Additional notes provided in response to Draft IAR.

April 9 2025

Review: Section 4_Landscape and Urban Form Macquarie Point Multi Purpose Stadium

Prepared for the Hobart City Council

Fig. 22.8 HIPS Diagrammatic section: The Amphitheatre to the Cove within the Urban Amphitheatre

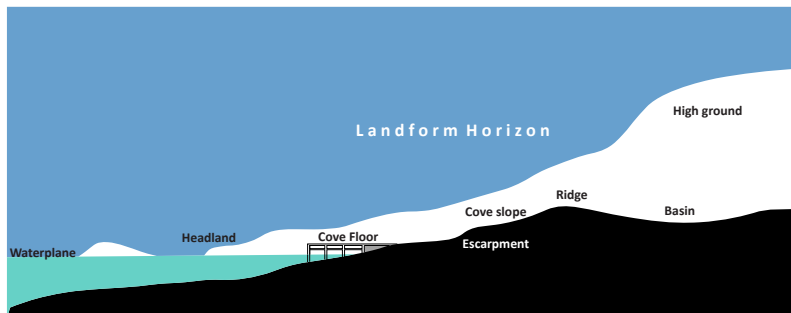
While there is a description of the local components: ‘Queens Domain’, ‘Cove’, ‘City centre’, the analysis does not extend to consider how these integrate with one another to gesture to how the landscape is experienced, notably in the context of the Urban Amphitheatre.

A ‘diagrammatic section’ is included in the current planning scheme (Fig. 22.8) to identify the spatial terminologies incorporated within the ‘Urban Amphitheatre’ and the ‘Amphitheatre to the Cove’. (The diagram is deliberately ‘scale-less’ and was only intended to be used in concert with the other figures, 22.7, 22.9) However it has been inappropriately copied as a literal ‘section’, (UDF p.100) to justify the scale of the proposed stadium.

Figure 133: Existing section demonstrating proposed relationship to the urban amphitheatre

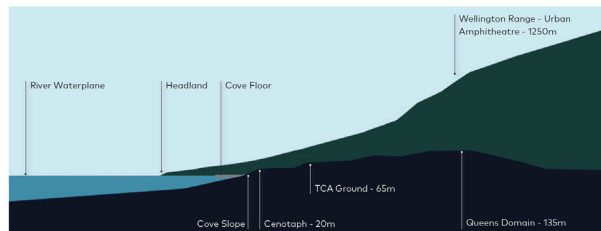
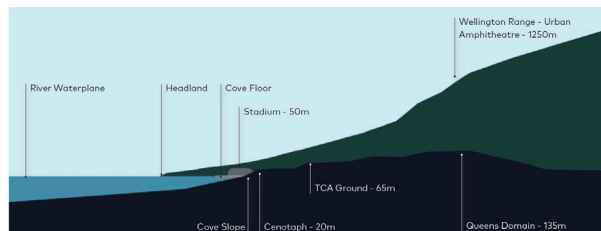
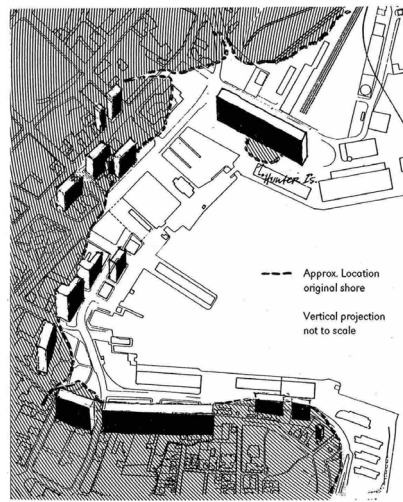
'Scale -less' diagrams copied from the Planning Scheme to inappropriately 'justify' the scale / bulk of the proposed Stadium. (UDF p.100)

View line 3 (VIA) Existing and proposed impact on views across the cove and down river.

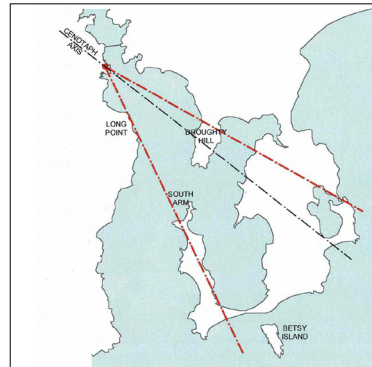
While the VIA recognises that views to Long Point will be obscured by the Stadium, (p.68) it must be assumed the author does not adequately appreciate the location of the 'mouth of the Derwent'. In this instance it is actually behind Long Point, while Storm Bay is more readily appreciated by the form of Betsey Island on the horizon. Accordingly two landform items assist in appreciation of the 'mouth of the Derwent' from the Cenotaph: the waterplane connection of Long Point, Lower Sandy Bay, and the presence of Betsey Island (located within Storm Bay) on the horizon. Both of these features will be obscured by the proposed Stadium. (VIA View 3 Proposed stadium- following page)

Notwithstanding architectural efforts to generate a contextual form in response to the brief, the presence of the Stadium above the Cenotaph headland is both individually prominent, and of a scale that obscures views across the Cove and down the river, especially to the 'mouth of the Derwent'.
